Limerick City
& County Council

**Re: Part VIII Planning Report for the Proposed Residential Development at Dromdarrig, Mungraet,
Co. Limerick**

**PLANNING REPORT IN ACCORDANCE WITH
SECTION 179 3(a) OF THE PLANNING & DEVELOPMENT
ACT 2000 (as amended)**

Planning Reference No. 21/8000

Figure 2.0 Section/ street elevation drawing

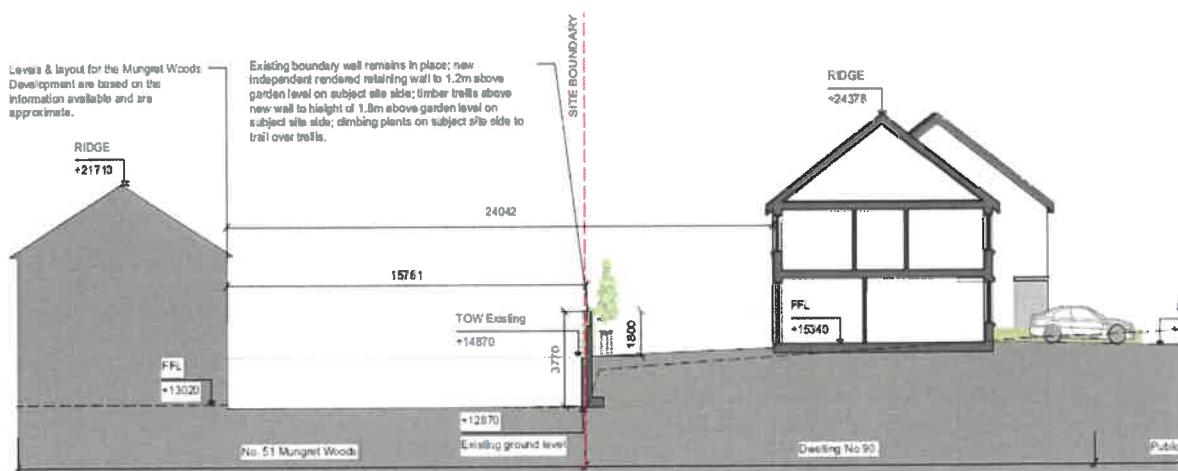
There is a difference of 1.35m in height between the proposed development (A2 site) and Munget Woods. The Munget Woods houses backing onto plot A2 already have a 1.9m high block wall defining the boundary of the rear gardens, which also functions as a retaining structure to accommodate the difference in levels between both sites.

The proposed boundary treatment will extend beyond the top of the existing rear boundary wall in Munget Woods by 1.25m, resulting in an overall boundary treatment height of 3.7m. This rear boundary treatment is located 15.7m from the constructed houses in Munget Woods thereby ensuring that no overshadowing (see figure 2.0). Whilst some overshadowing of rear garden areas will occur at certain times during the day, much of the overshadowing already occurs as a result of the existing 1.9m high rear garden wall. The BRE Report, Site layout planning for daylight and sunlight: a guide to good practice (BR209), advises on planning developments for good access to daylight and sunlight. The BRE guidelines recommend that at least half of the garden or open space can receive at least two hours sunlight on March 21. It is considered that this standard can be achieved and that no overshadowing adverse impacts occur.

Figure 3.0 Tree & Hedgerow Survey

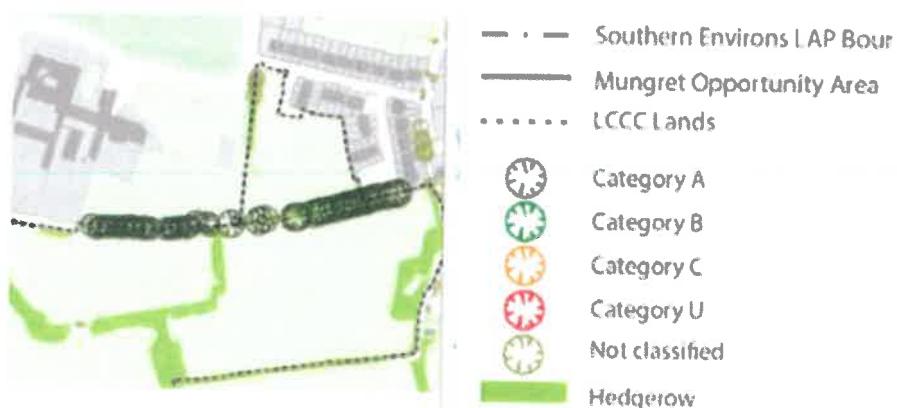
- 1) The area designated A2 of the overall proposal has not been provided the correct ecological designated in our view.
This area attracts many forms of birds, butterfly and bees all year round. The area contains naturally regenerating willow and dense scurb flora which provide an excellent habitat for wildlife and is a great example of natural biodiversity in action.

In respect of the habitat and biodiversity of the site, it should be noted that Appendix B of the Appropriate Assessment Screening Report contains a comprehensive Baseline Ecology Report undertaken in respect of a significant land area comprising Munget College and surrounding lands. Contrary to the content of a number of submissions, it concludes that there are no protected plants or species of conservation value identified within the study area. It also confirms that the habitat required to be removed includes agricultural grassland, scrub habitat, sections of hedgerows and treelines. These habitats were assessed as being of local importance and the report confirms that the loss of such habitat within the study area does not constitute a significant effect. A Tree and Hedgerow Survey was carried out by Arbocare in May 2018, which concentrated on the significant trees and hedgerows located within the subject site. The survey identified the location of trees and hedgerows and their quality. There is a line of Category A (high quality and value making a substantial contribution) trees along the northern boundary of plot A1 and A3 and a number of trees along the western boundary of Plot A2 which have not been classified (Refer to Figure 3.0 below). None of the trees are protected by a Tree Preservation Order (TPO). Irrespective, it is proposed to retain this tree and hedgerow line in so far as possible within the development proposal.

Specifically, the Arboricultural Impact Assessment confirms that the arboricultural impact of the development is low, with only three trees out of forty-three trees requiring removal. Approximately 7,523m² of overgrown hedgerow vegetation will be removed. However, considering their low species diversity and the replanting strategy which will result in the replanting of approximately 500 linear metres of hedgerow within the site, the effect is not significant. There is also an extensive landscape plan that will plant the site with appropriate trees which will enhance the arboreal footprint of the site. The Arboricultural Report also recommends a number of measures to be adopted during construction stage including the provision of protective fencing defining the root protection area. This will ensure that
